## ADDENDUM NO. 04

MOUNTAIN TRANSIT MAINTENANCE FACILITY

**FOR THE**  
MOUNTAIN AREA REGIONAL TRANSIT AUTHORITY (MARTA)

RCA Project No. 5-08-01

PEMB WIN. HEAD 2 SCALE: 3" = 1'-0" REF.: 1/A1-2.1 1

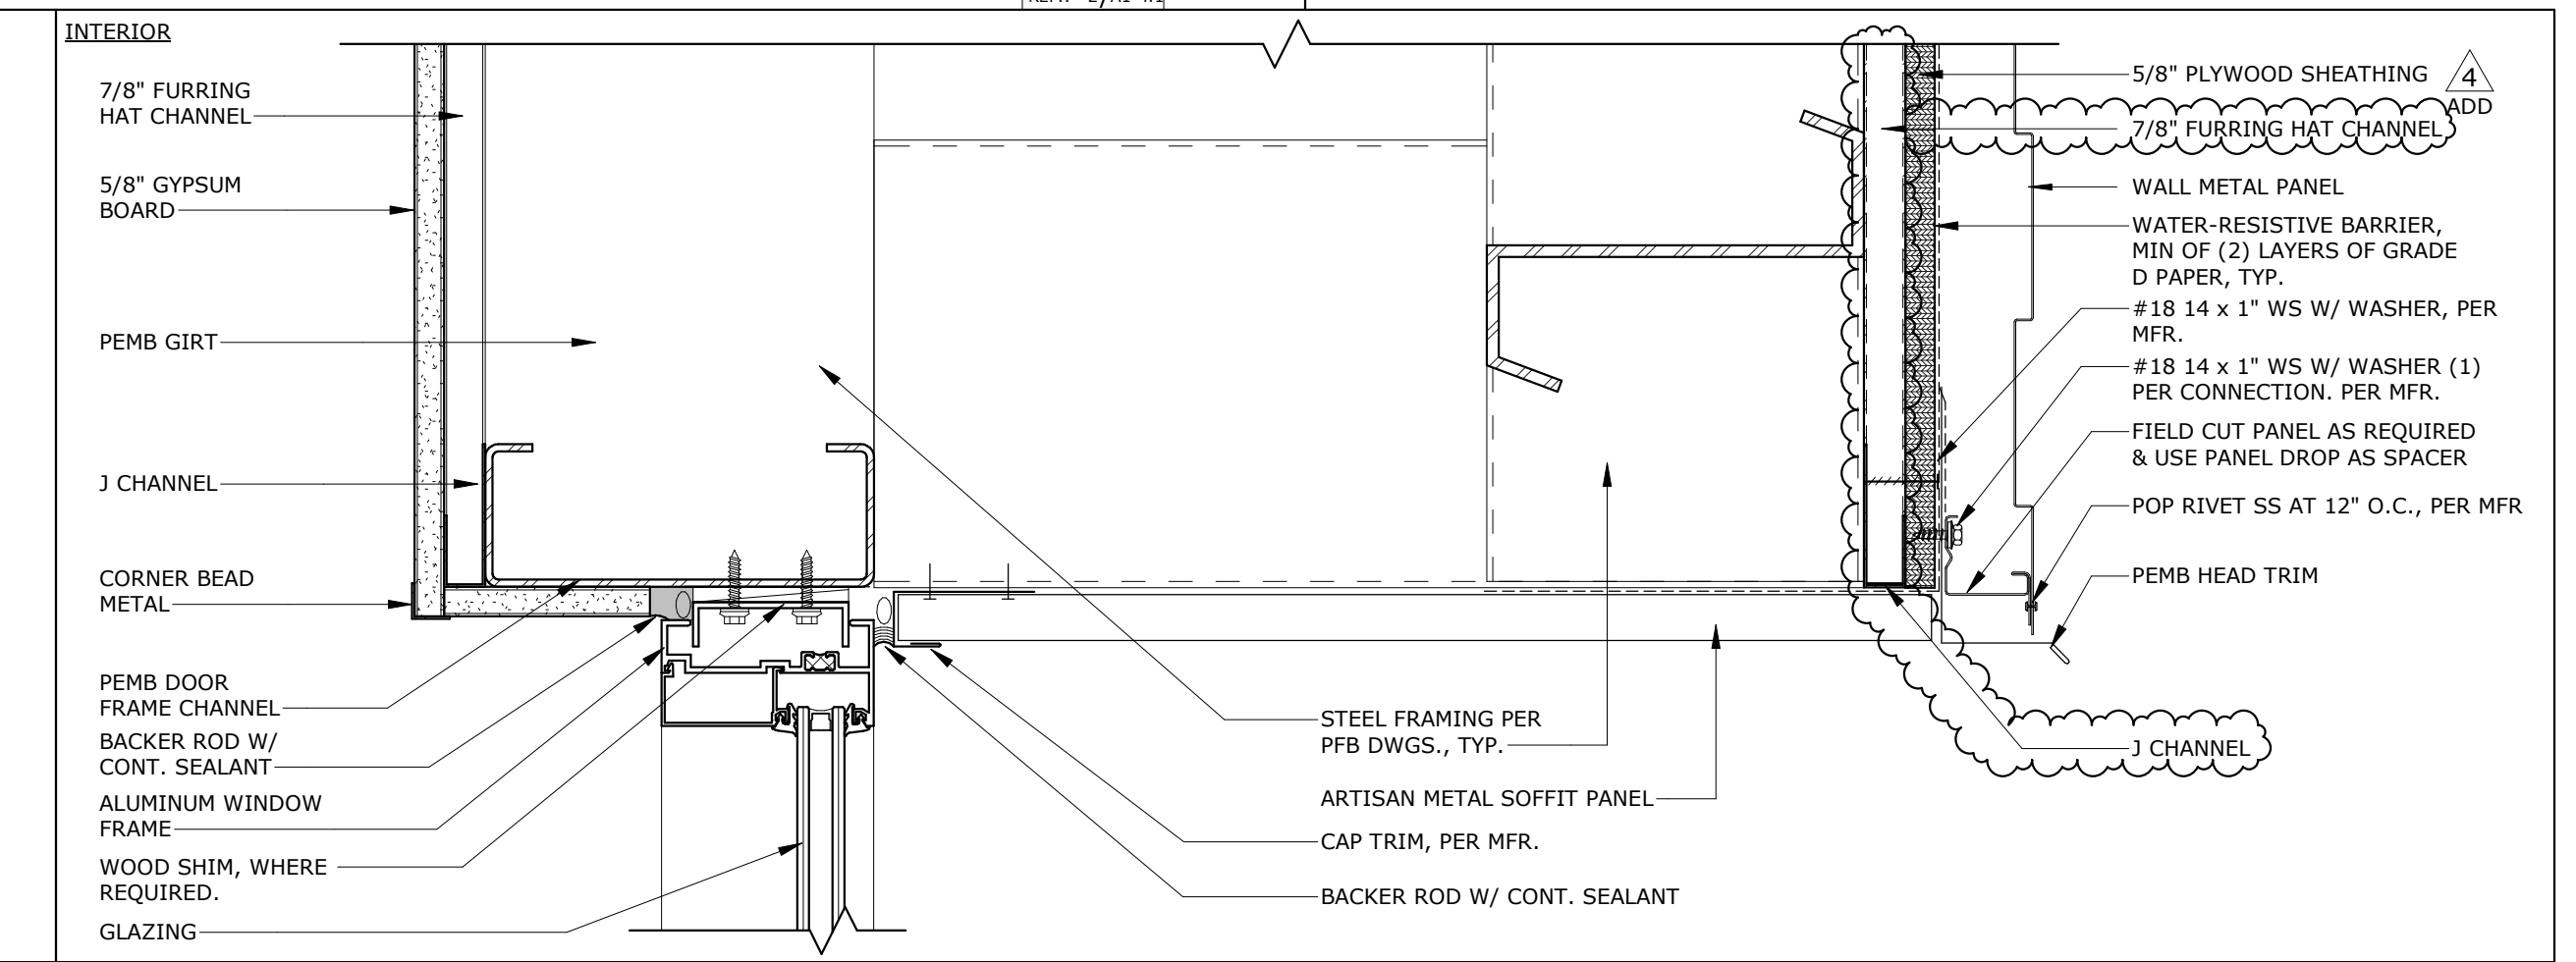
- a) Revised detail 1/AD-6.2 – PEMB Win. Head 2 per clouded area. Added 7/8" furring hat channel.
- b) Revised detail 3/AD-6.2 – Sectional Door Head per clouded area. Added blanket batt insulation.
- c) Revised detail 4/AD-6.2 – Sectional Door Jamb per clouded area. Added blanket batt insulation.

**TRASH & ELEC. YARD FOUNDATION AND ROOF FRAMING PLAN**

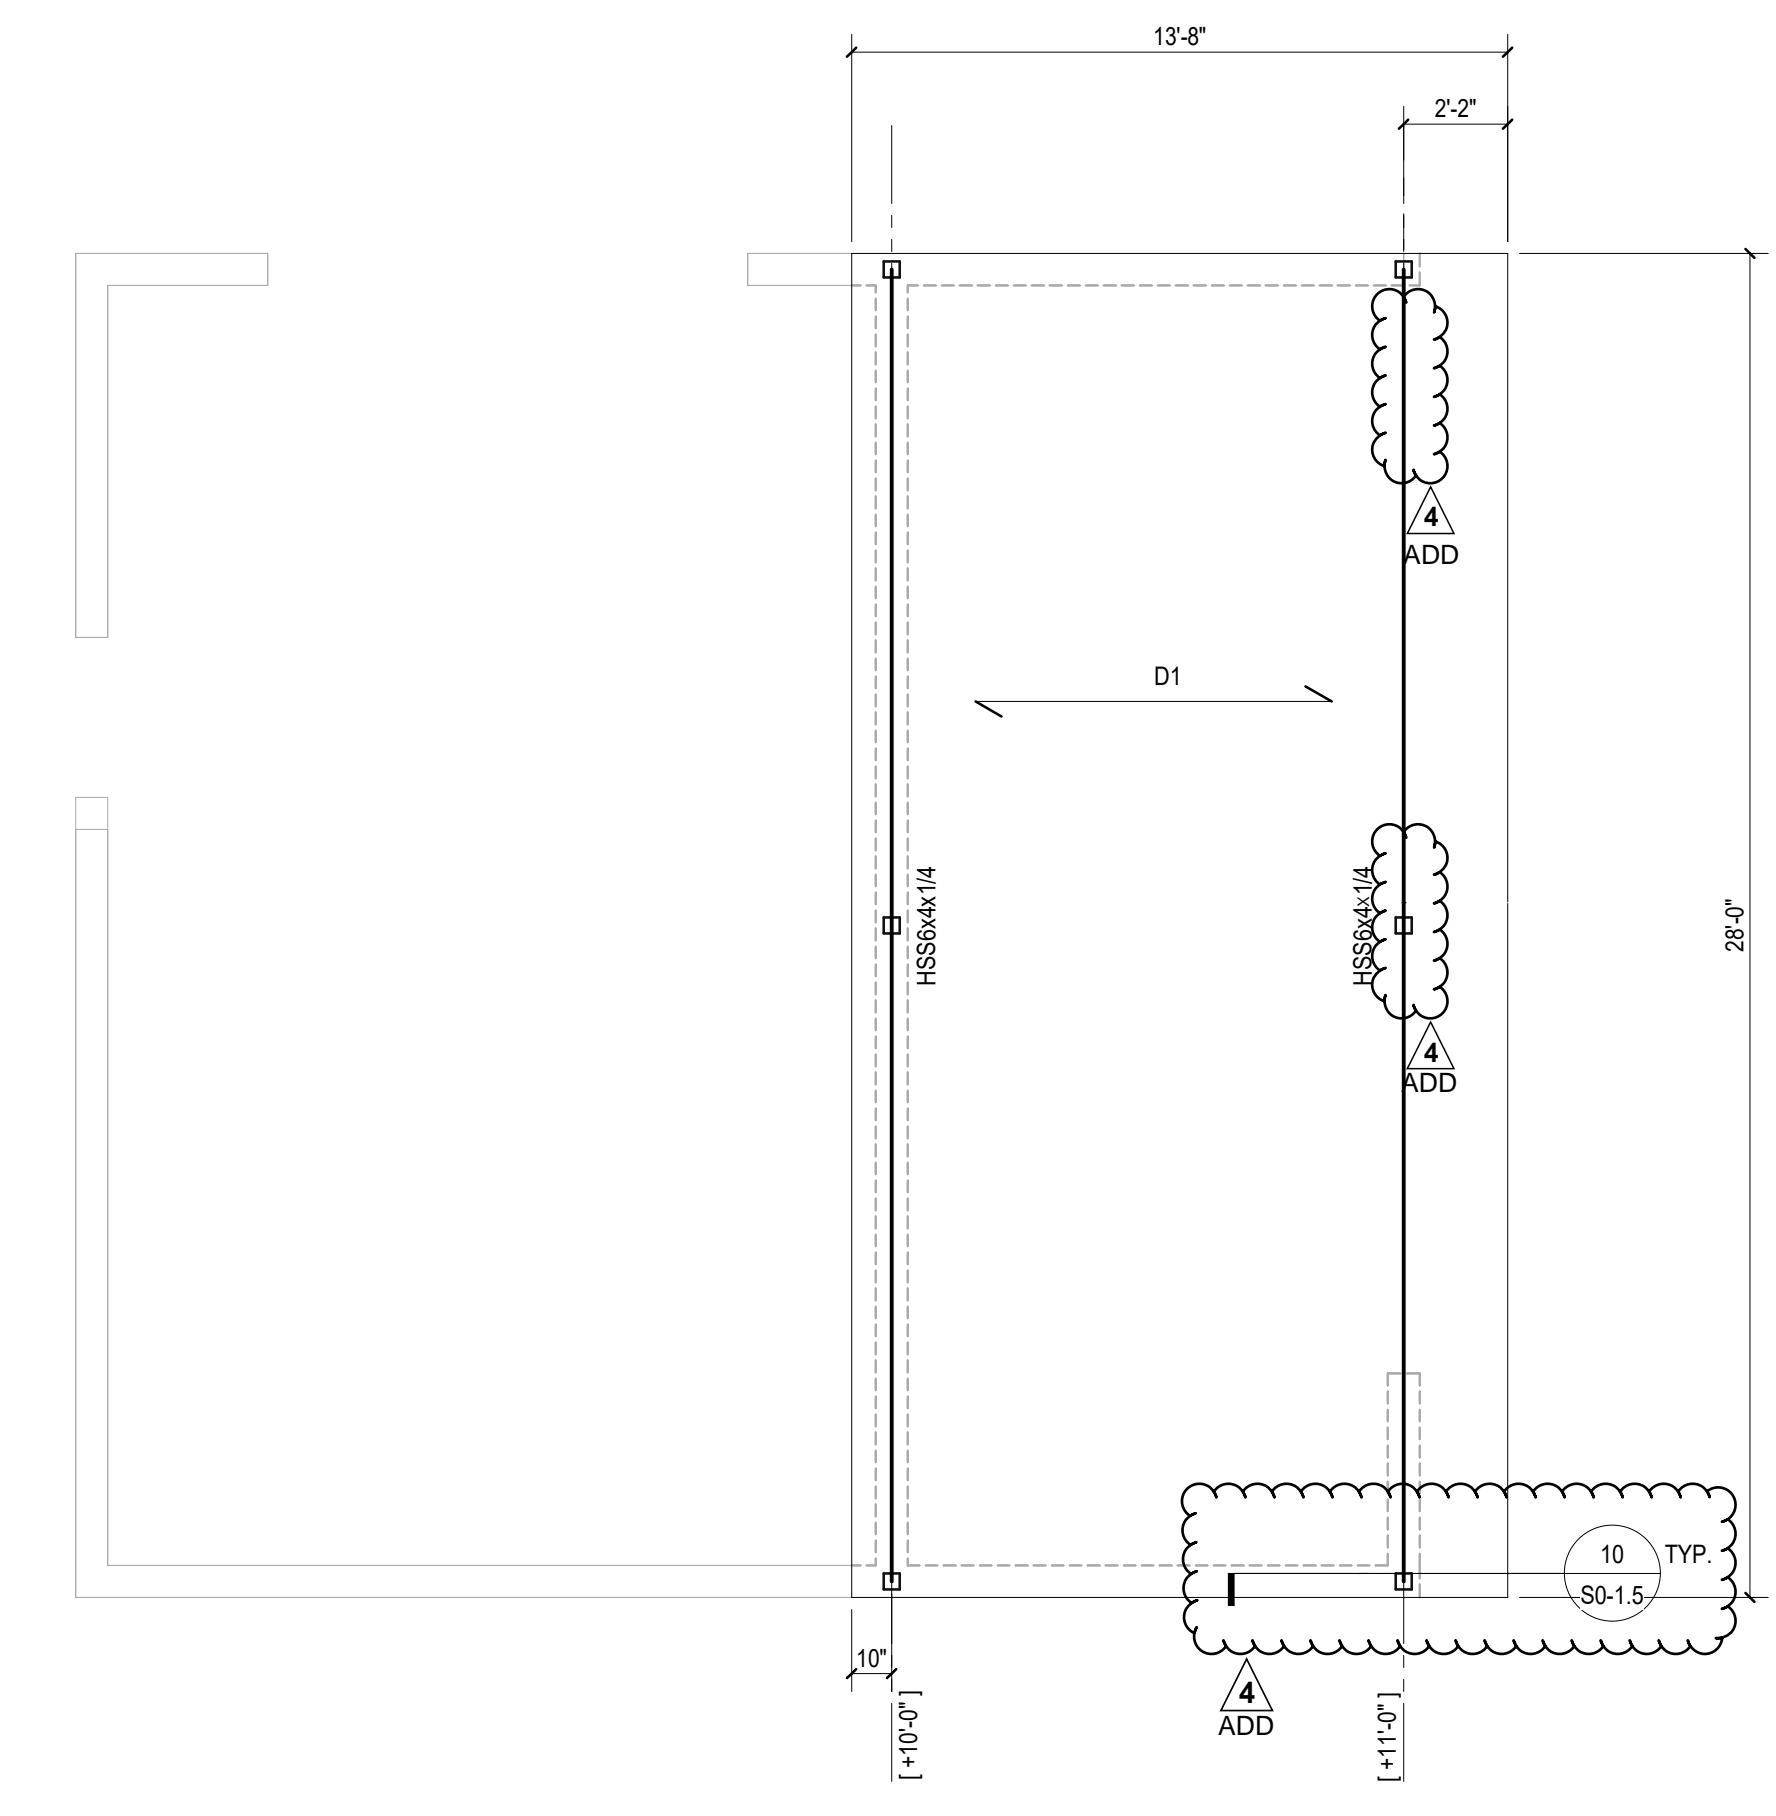
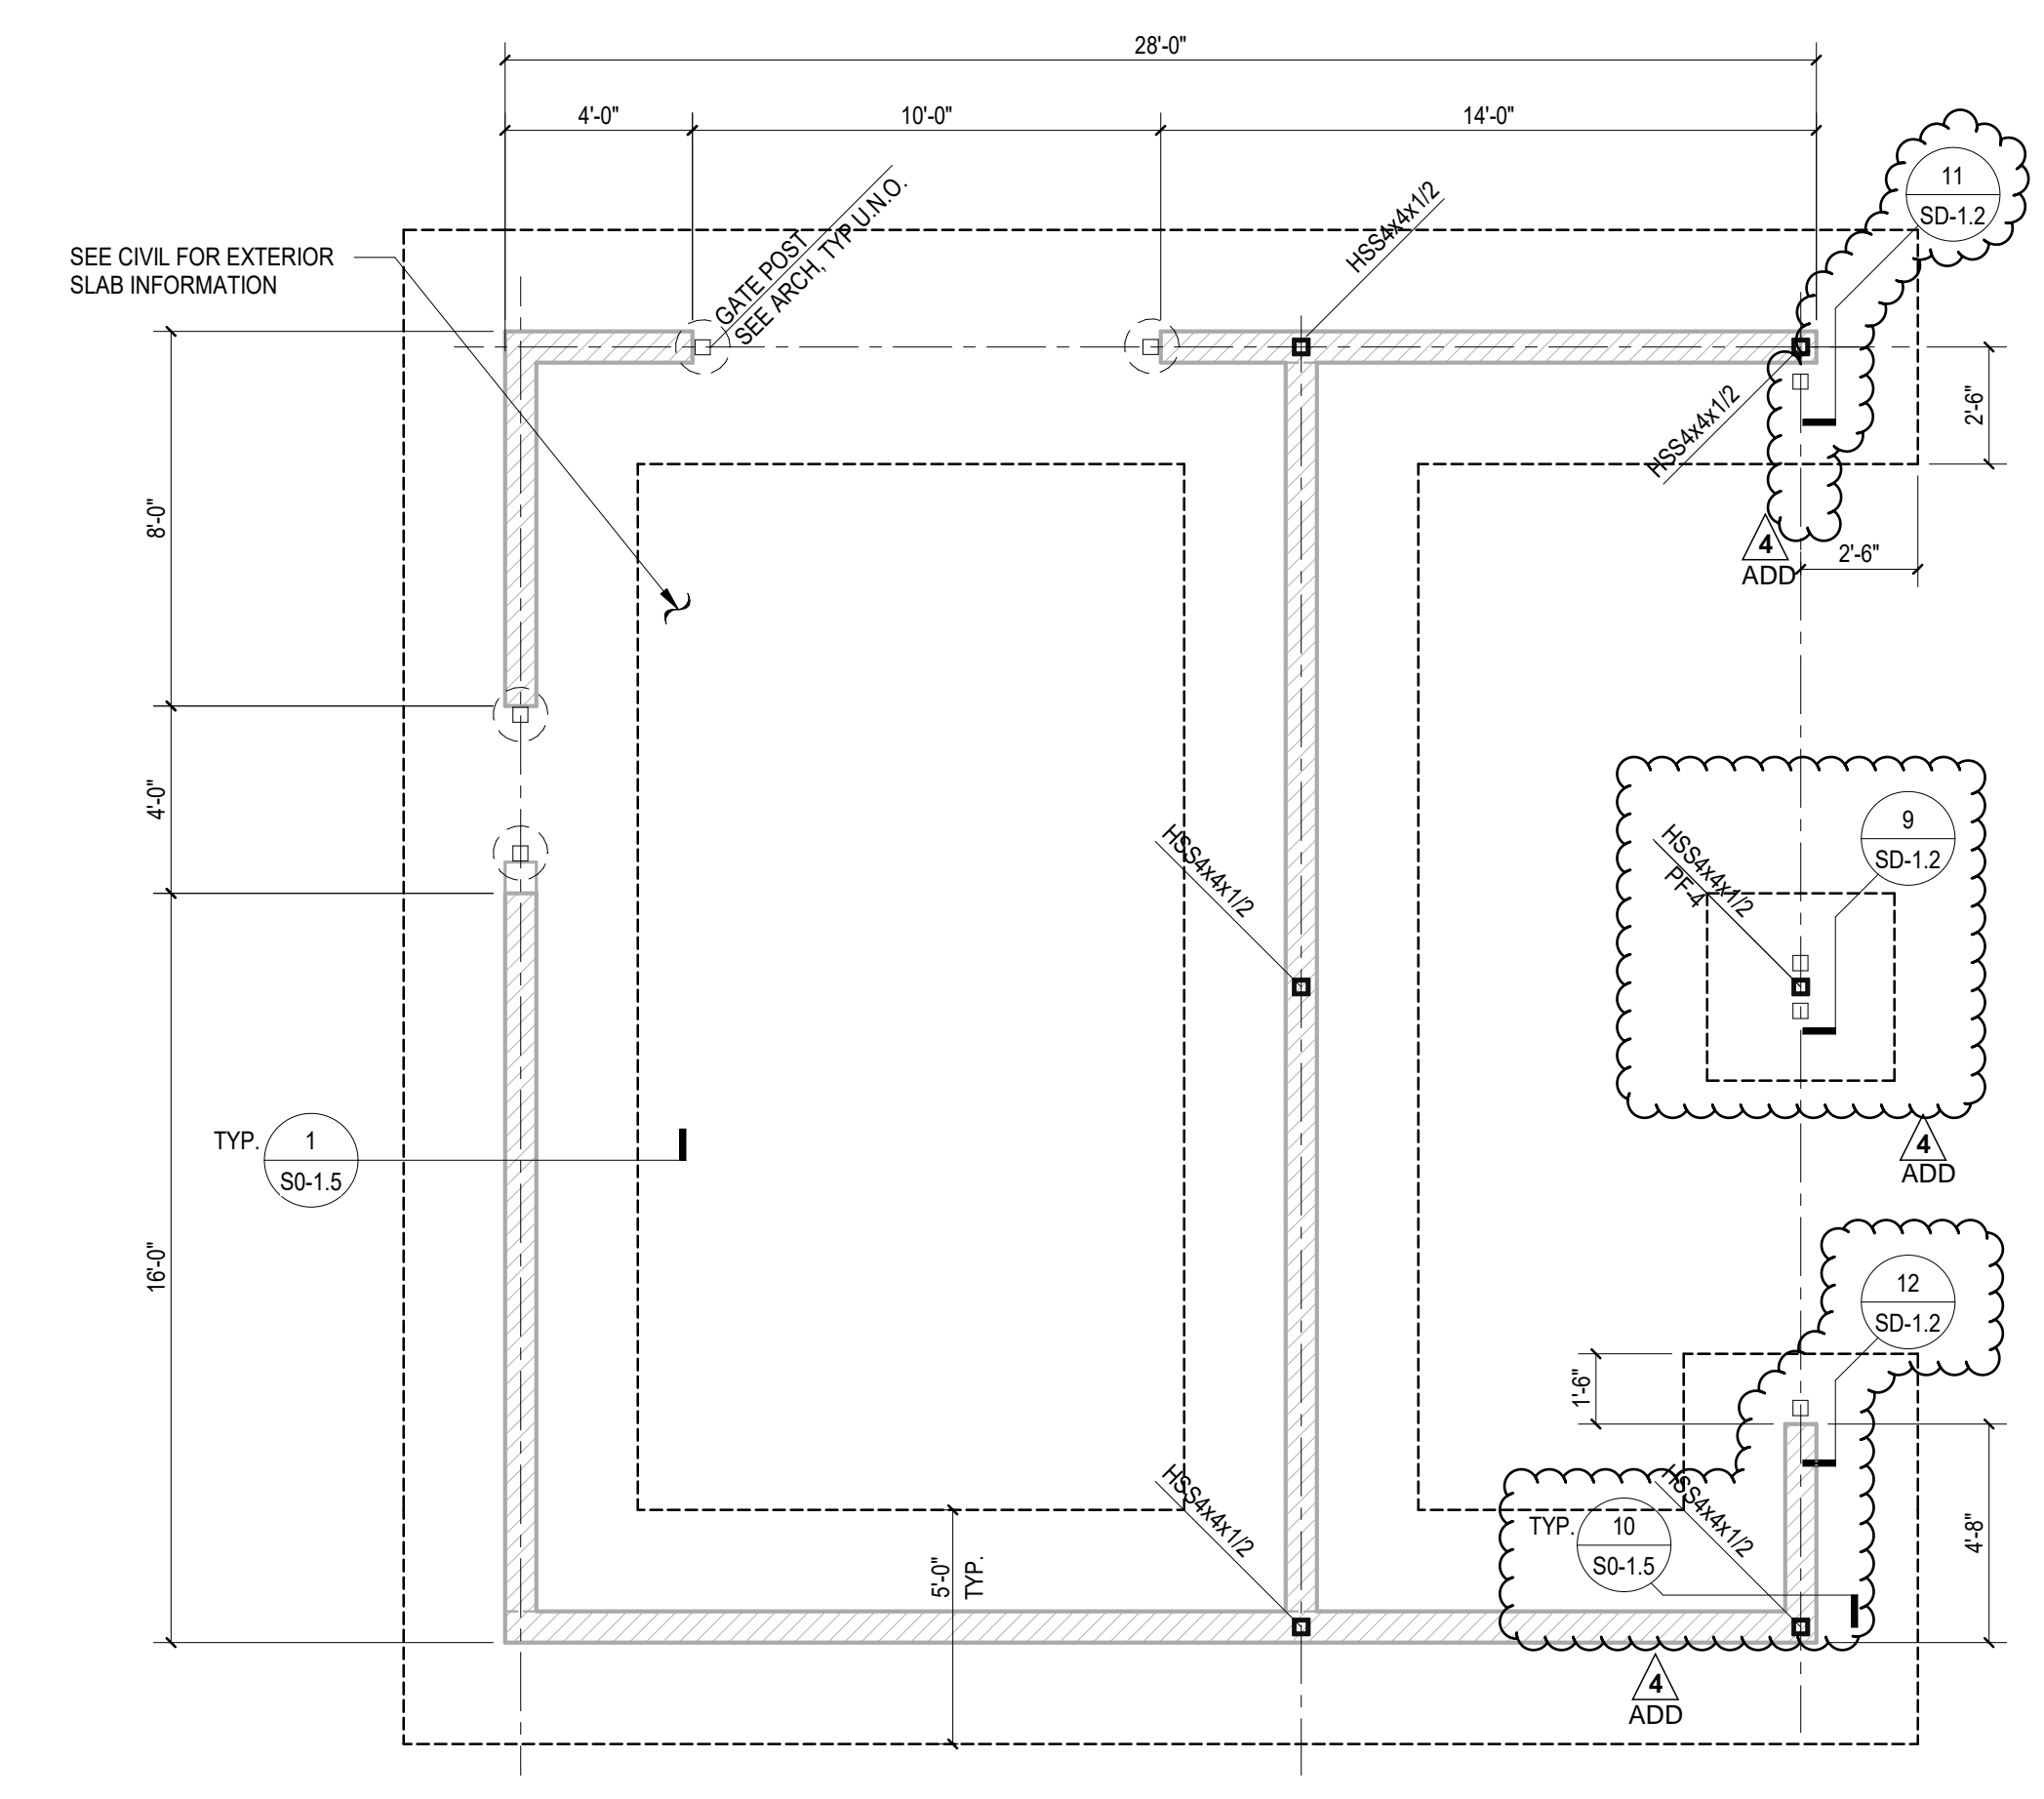
a) Revised 2/S2-1.1 to show revised, larger gate & columns.  
a. Removed portion of wall outline at North most gate along east wall.  
b. Removed middle portion of CMU wall between gates.

c. Added detail 10/S0-1.5 for HSS to roof deck connection.  
b) Revised 1/S2-1.1 to show revised walls and gate connections.  
a. Removed portions of CMU wall along east wall.

b. Added detail reference 11/SD-1.2 at N-E corner for foundation & gate post.  
c. Added detail reference 9/SD-1.2 for centered E-side foundation & gate post.

d. Added detail reference 12/SD-1.2 for S-E corner foundation & gate post.
- Item No. 4.31 Reference Sheet SD-1.1 – Foundation Details  
4.31.1 Replace Sheet SD-1.1 and revise per clouded areas listed below:

SCALE: 1"=1'-0" DETAIL 1

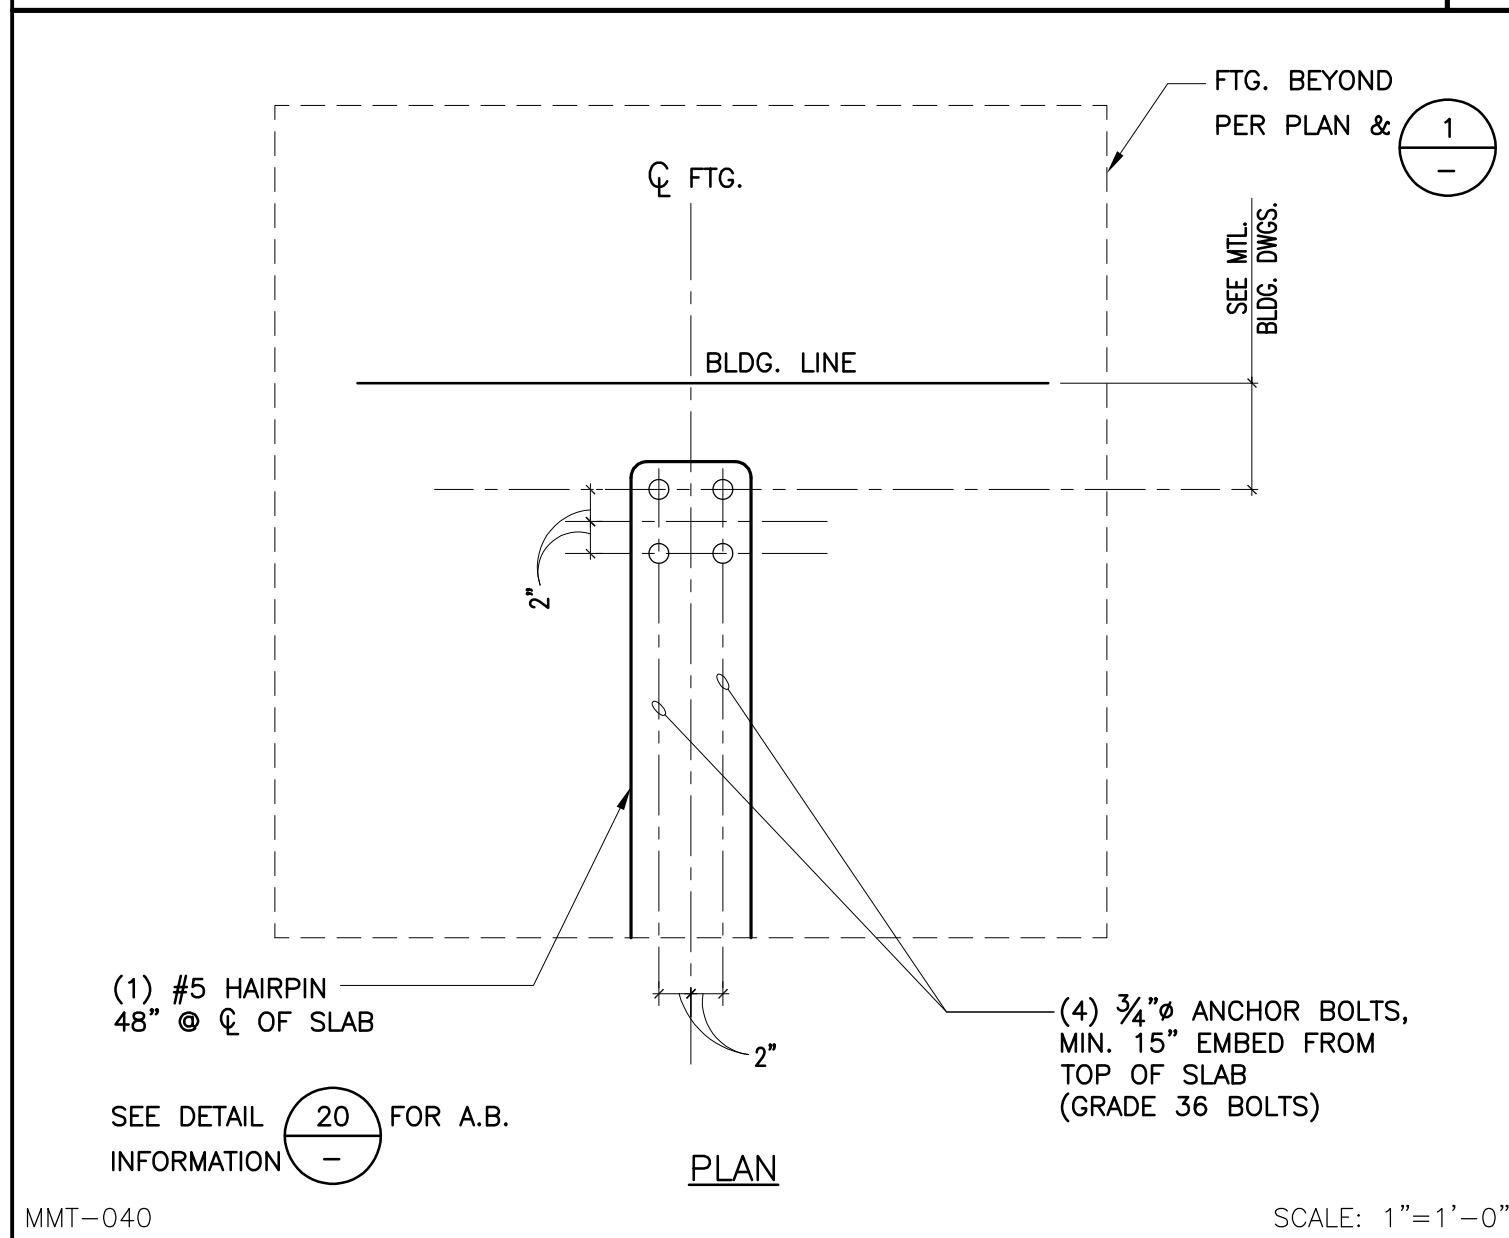
a) Added PF-4 option to detail 1/SD-1.1
- Item No. 4.32 Reference Sheet SD-1.2 – Foundation Details  
4.32.1 Replace Sheet SD-1.2 and revise per clouded areas listed below:
